## **CONSTRUCTION SUMMARY**

## Lindsay 2017 Developments Inc. / Sugarwood

Lot/Unit: 89 Block 78 Phase/Building: 1 Model/Floor Plan: Mitchell Lake(2002)Elev A 3Bed 2.5Bath

Townhouse No. 89 Block 78
Phase 1
Model: Mitchell Lake(2002)Elev A 3Bed 2.5Bath
Standard
SKLI-Ch H [

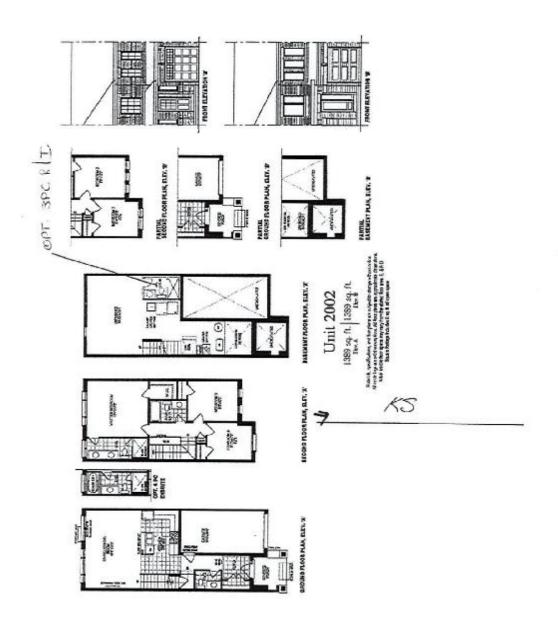
Inv. <b>5453</b>	1 - To supply & install the optional 3pc rough in the unfinished basement see sketch # 1	
Line 70255	Note:	
15Mar22 / 15Mar22
